1. This note has been prepared by Scotch Partners LLP (SP) in response to comments made by the London Borough of Camden (LBC) regarding the *Noise Impact Assessment* for 3-6 Spring Place, dated May 2018.
2. For ease of reference, comments have been taken from the London Borough of Camden’s email, dated 05 February 2019, and Scotch’s responses have been provided below.
3. **LBC Comment:** *In terms of “Plant Noise” reference should be made to Table C of Appendix 3 of the Local Plan 2017.*
4. **SP Response:** We have assessed external plant noise against the planning condition which Camden placed upon the original development rather than the design criteria in the updated *Local Plan 2017* as this came into force after the original planning submission. Reference was made to this in Point 1.3 of the *Noise Impact Assessment*.

Figure 2 First floor external plant layout, ventilation

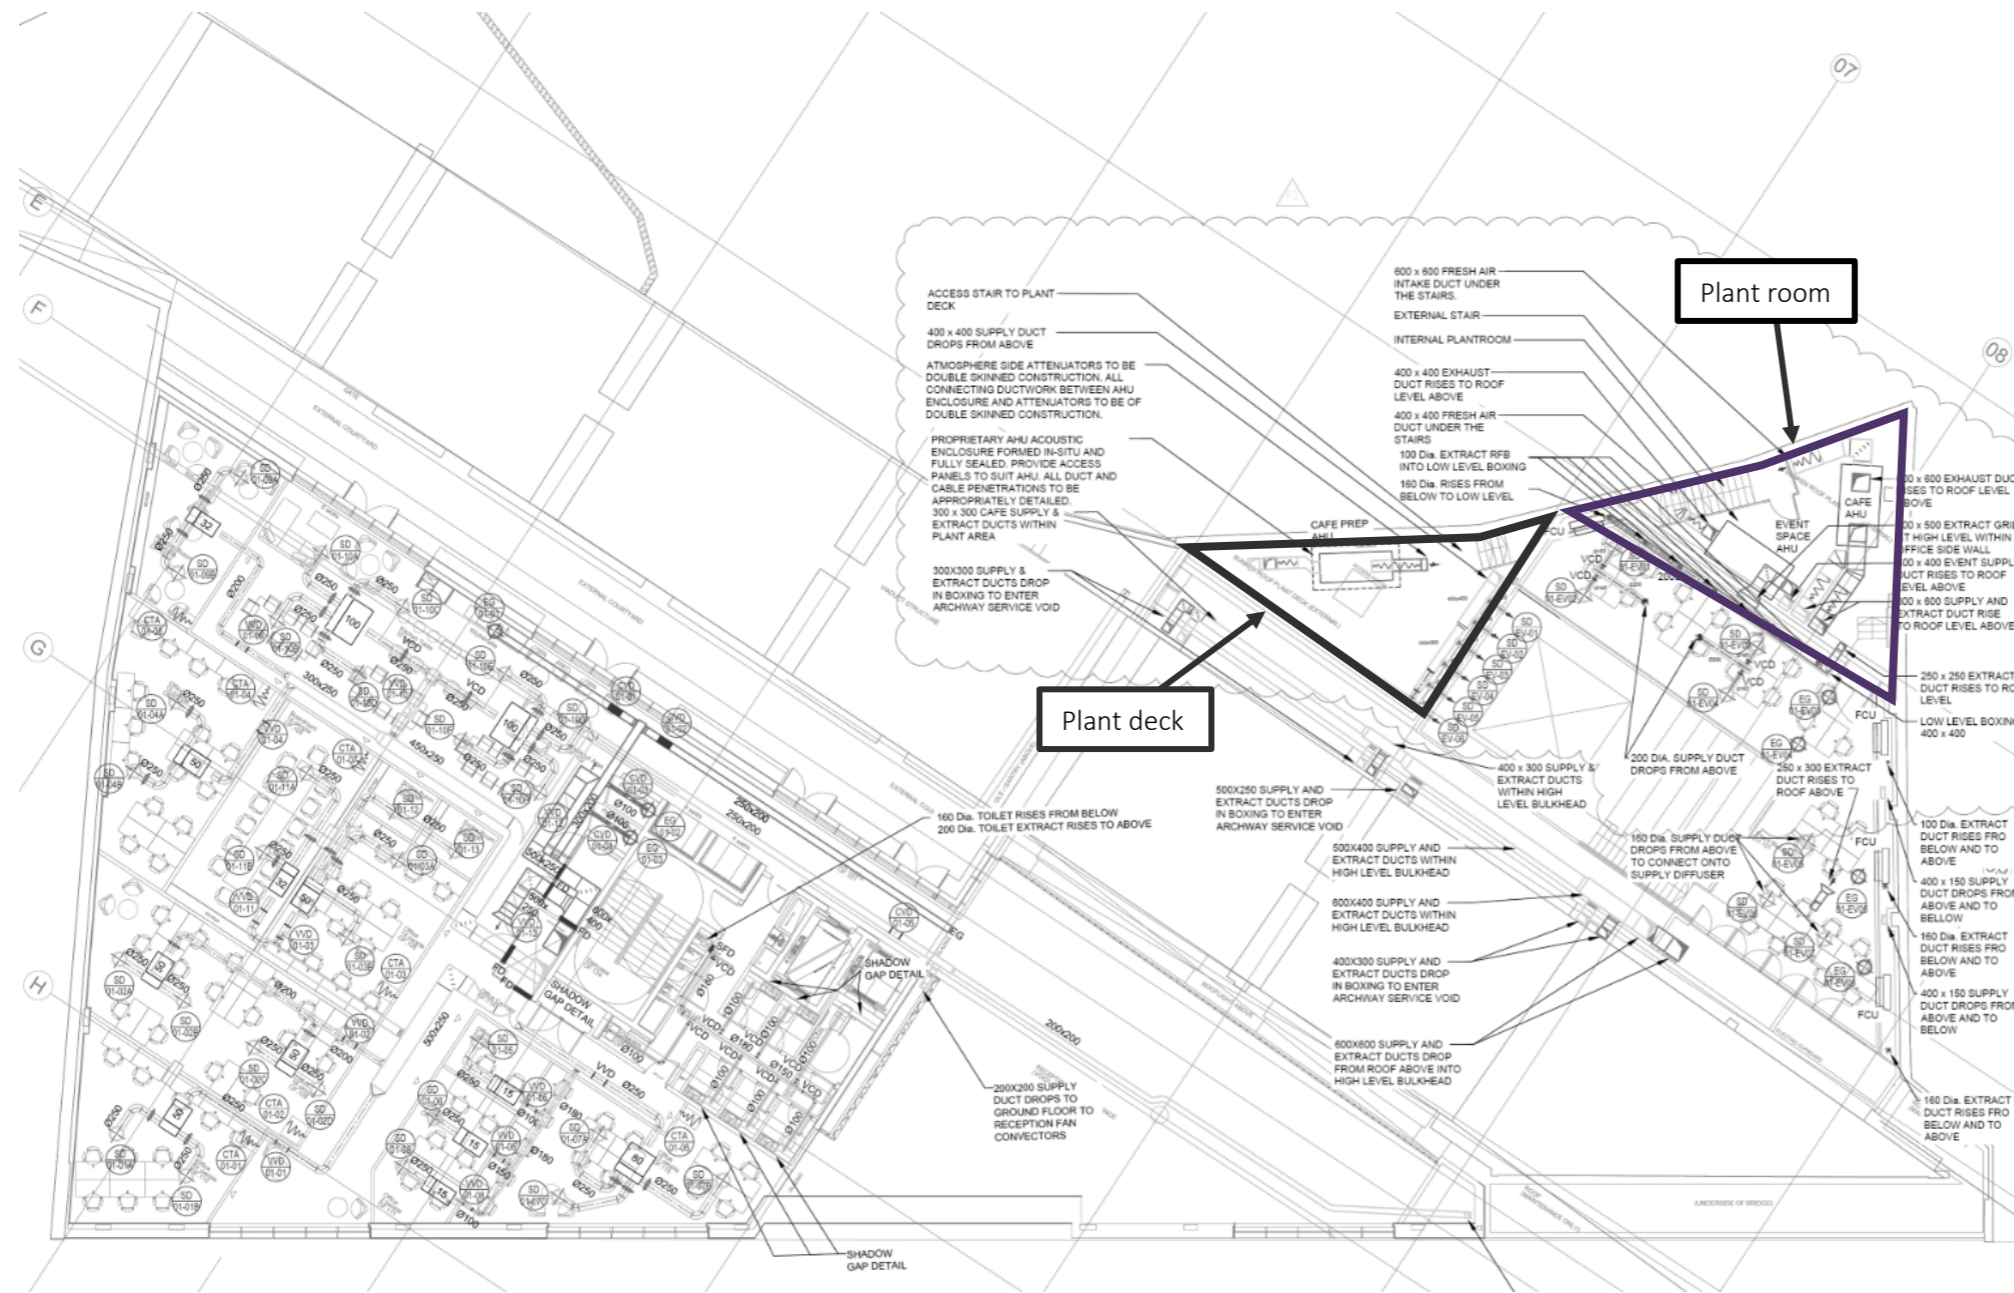
5. **LBC Comment:** *Although these items are to be installed at first and fifth floor roof levels, it’s not clear from the NIA which items of plant will be installed where.*
6. **SP Response:** Table 3-2 and Figure 3-2 on pages 8 and 9 of the *Noise Impact Assessment* set out the plant details and their location. Point 3.3.2 of the *Noise Impact Assessment* also makes reference to the drawings by Cundalls which were included as part of the planning submission for the exact positioning of plant items. We have appended these drawings (Appendix B) to this document for reference.
7. **LBC Comment:** *Separating distances between NSRs and first and fifth floor plant areas are not stated.*
8. **SP Response:** The following distances between plant items and NSRs have been assumed:

Location	Plant item	No.	Distance to noise sensitive receivers (m)	
			110-114 Grafton Road	7 Spring Place
Fifth floor plant area	Condensers	16	30	45
	Air handling unit	1	30	45
Rooftop	Extract fan	1	30	40
Event space rooftop	Heat recovery unit 1	1	10	4
	Heat recovery unit 2	1	12	4
First floor rooftop	Air handling unit 1	1	5	5
	Air handling unit 2	1	5	4
	Air handling unit 3	1	5	20
	Condenser	1	8	20
Bin store	Condensers	4	25	20
